# Linac4 BIS modification

LINAC4 Project Document No.  
**L4-CIB-ES-0001 rev. 2.2**

**BEAM INTERLOCK SYSTEM  
SPECIFICATIONS FOR LINAC4, TRANSFER  
LINES AND PS BOOSTER**

## Linac4 BIS layout before modification

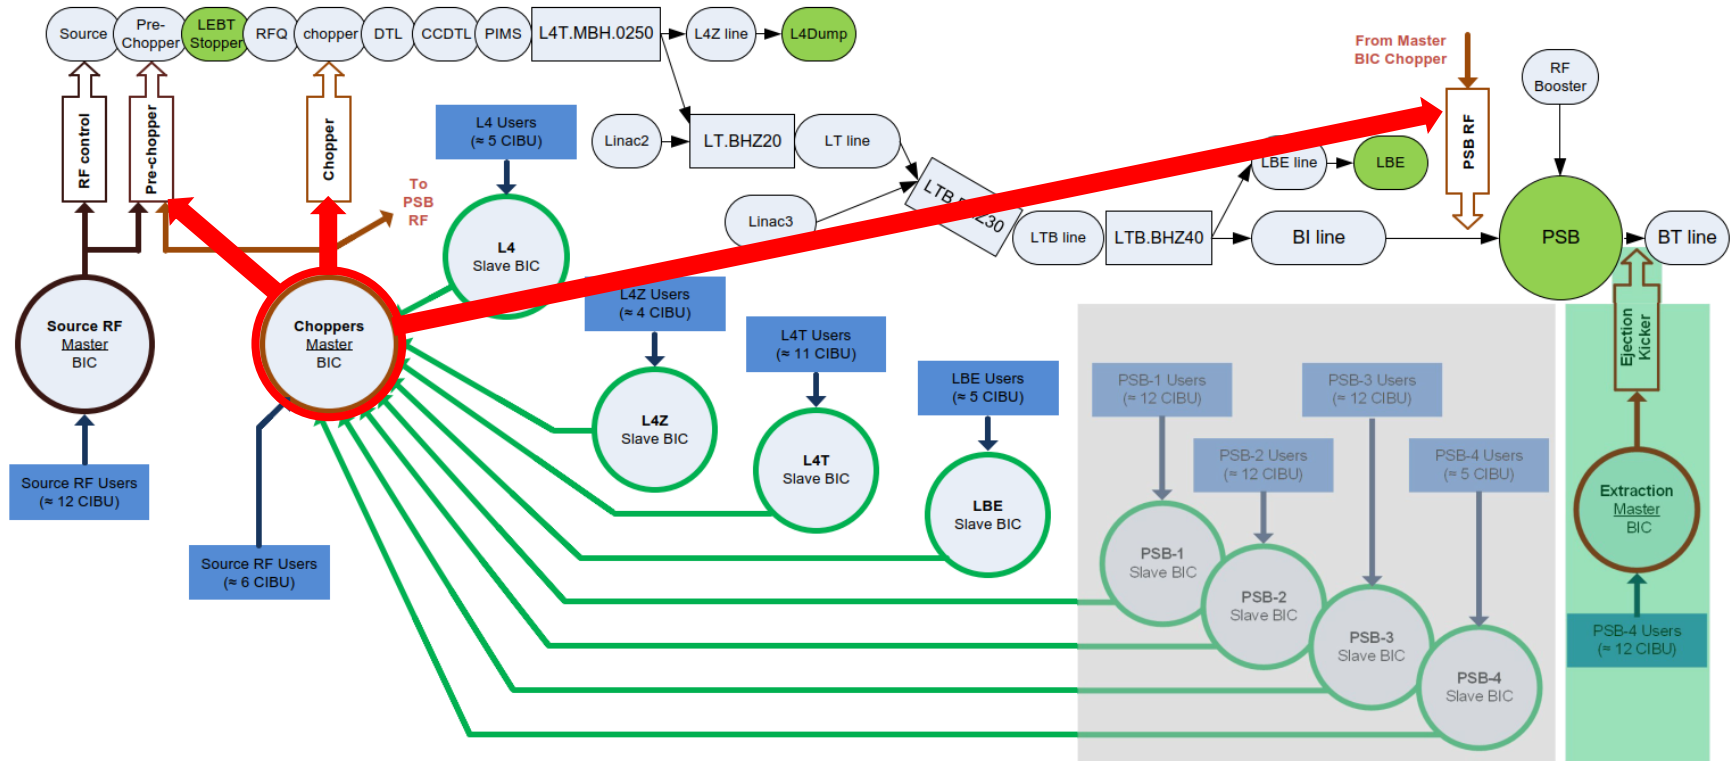
In the original specification the Master Chopper BIC acts on 3 actuators :

- The Chopper as main actuator
- The Pre-chopper as first redundancy
- The PSB RF as second redundancy

This Beam Permit has a typical duration of 600us (depending on the Linac4 configuration). The pulse duration is too short for the PSB RF actuator and is not synchronised on the PSB RF timing.

The RF electronic should have been modified to take into account this Beam Permit (extend the length, resynchronise on PSB RF ...)

As the PSB RF actuator is a "second" redundancy, it has been decided to not connect the Chopper Master BIC output to the PSB RF.

The BIS Linac4 engineering specification has been modified and is under approval (no ECR, just new version to be approved by involved experts)
